CCK-2568-22

ADDENDUM # 4

CONSTRUCT/ IMPROVE GREEK HOUSING (DELTA GAMMA) Bid Package #2 – All Work Categories

UNIVERSITY OF KENTUCKY
 2555.0 Construct/Improve Greek Housing
 (Delta Gamma House)

2 VEHICULAR RATED CONCRETE AT DUMPSTER PAD
 SCALE: 1/4"=1'-0"

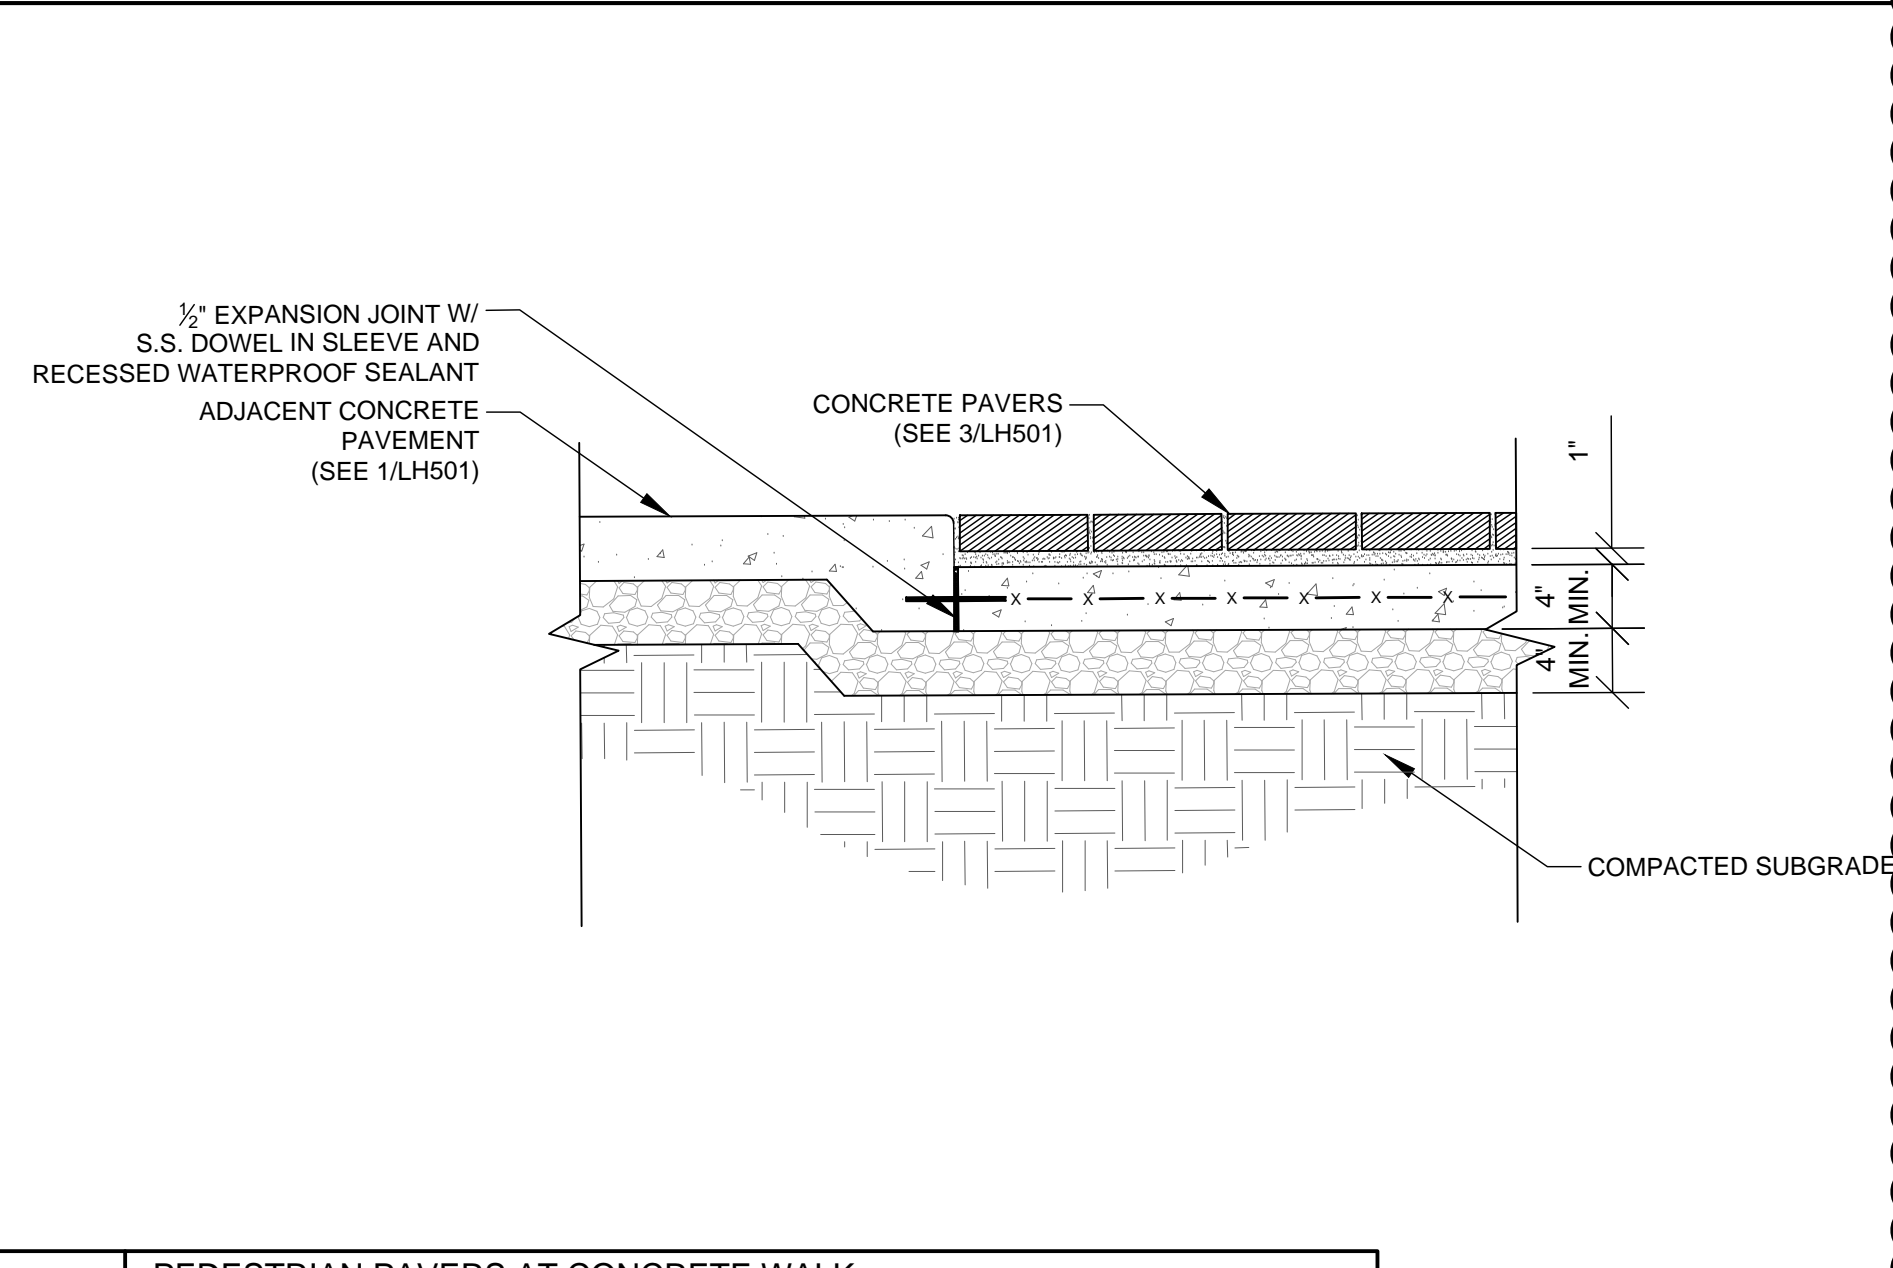
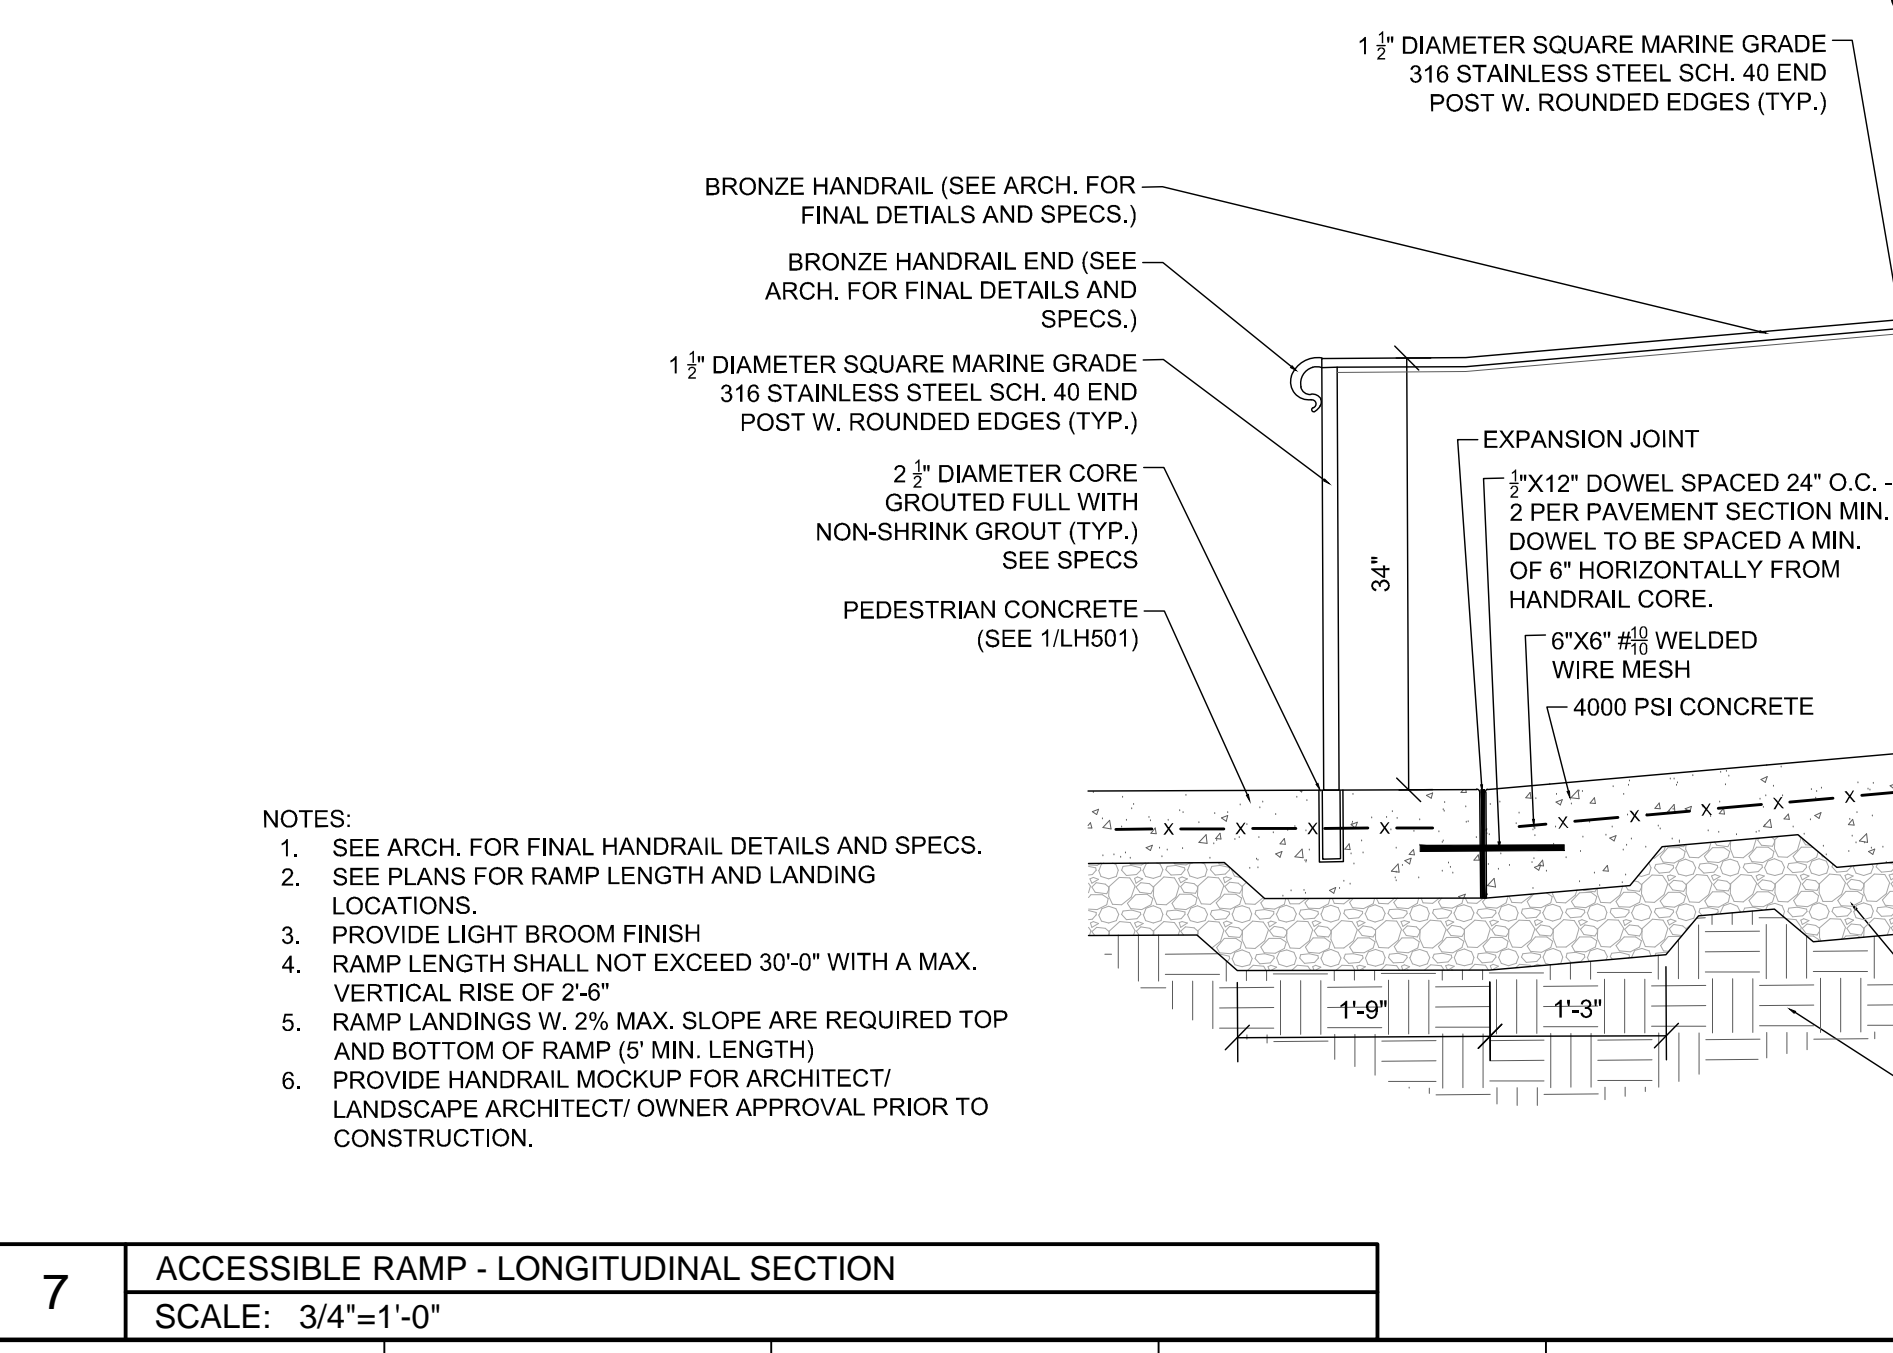
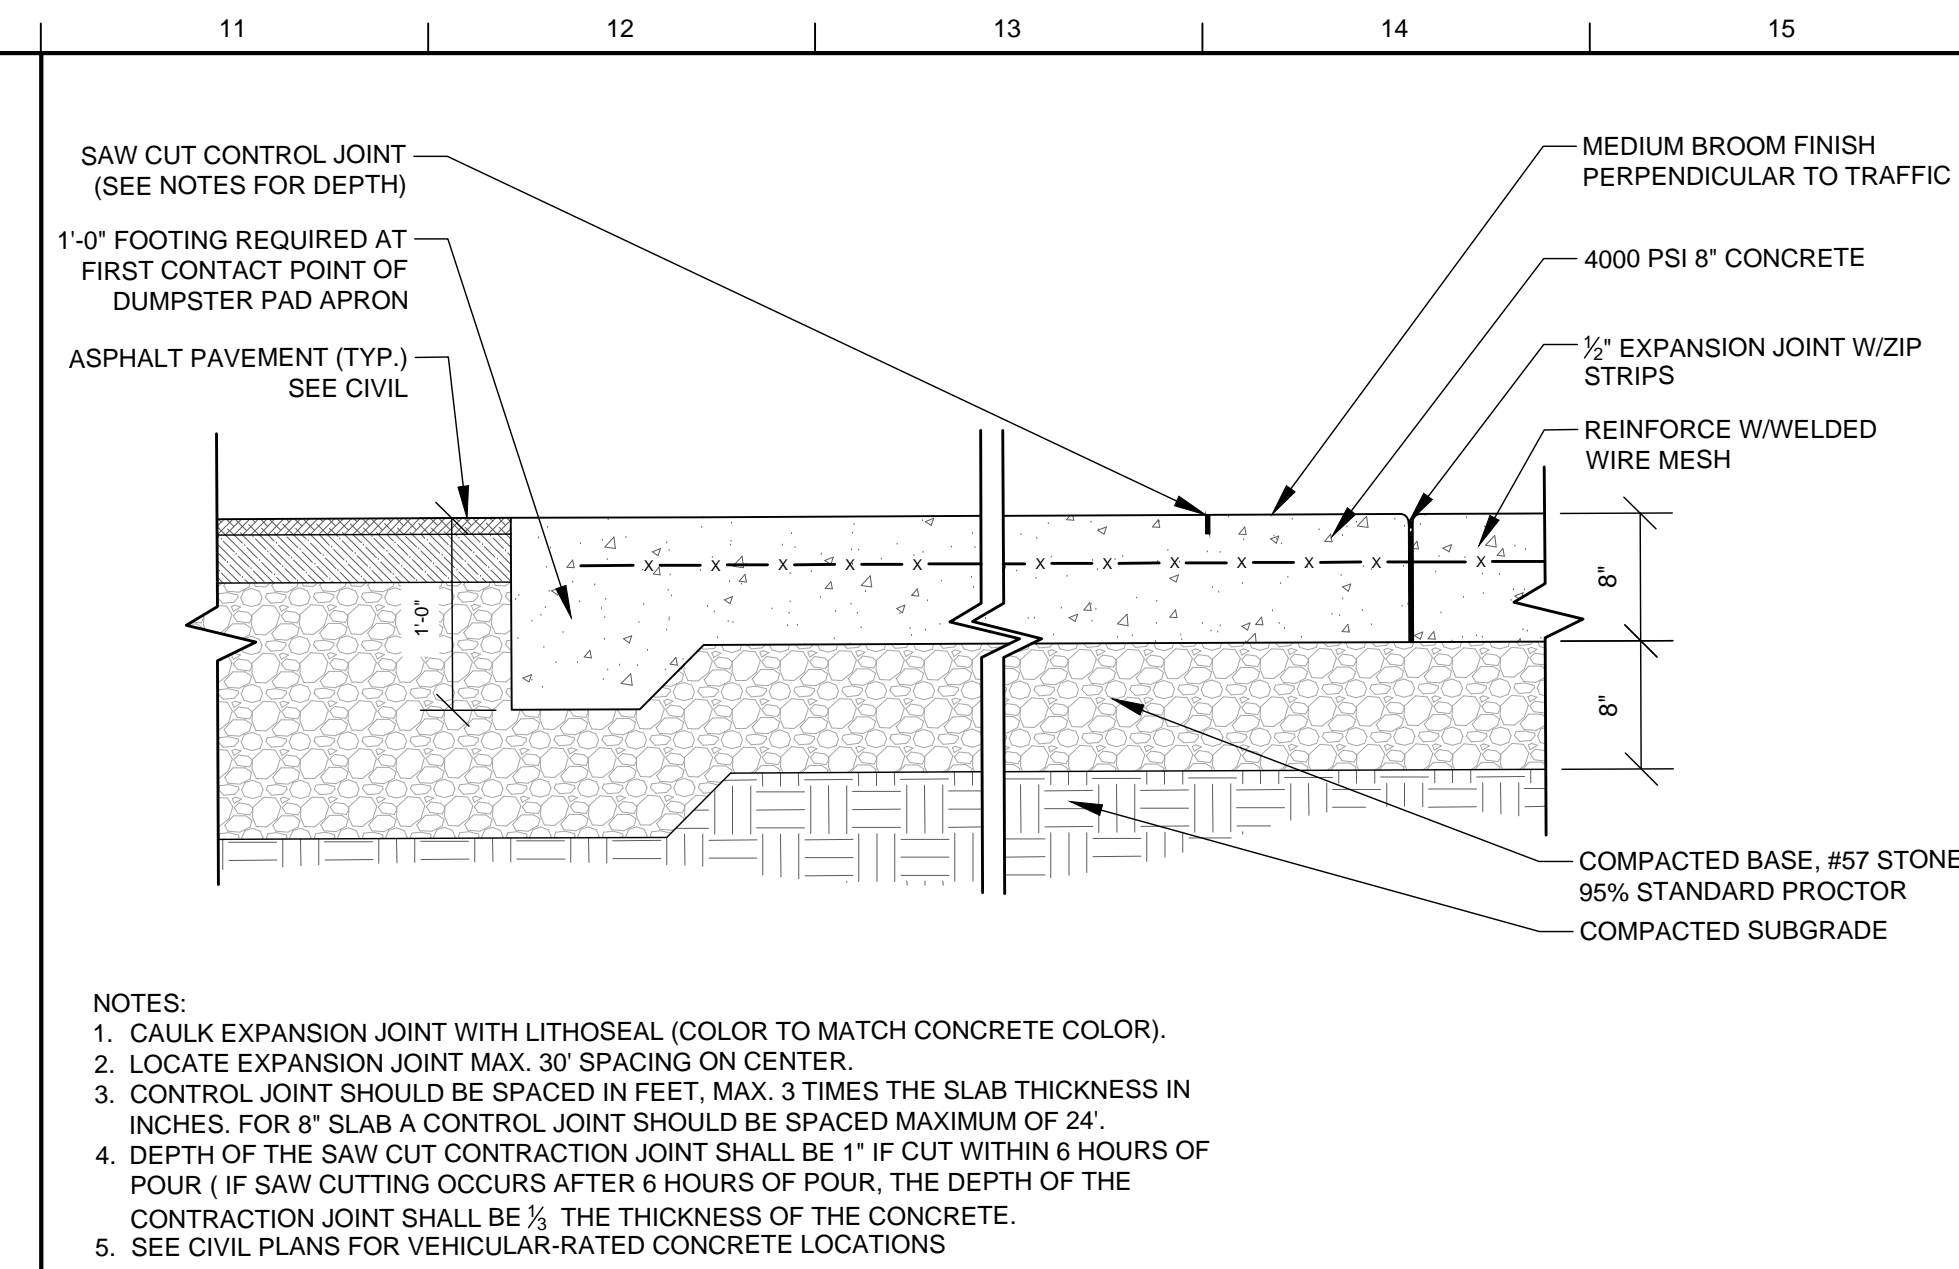
LH501	HARDSCAPE DETAILS	9/7/21
	<ul style="list-style-type: none"> • Wall detail labels and footings revised 	
LH502	HARDSCAPE DETAILS	9/7/21
	<ul style="list-style-type: none"> • Wall detail labels and footings revised 	
LH503	HARDSCAPE DETAILS	9/7/21
	<ul style="list-style-type: none"> • Wall detail labels and footings revised
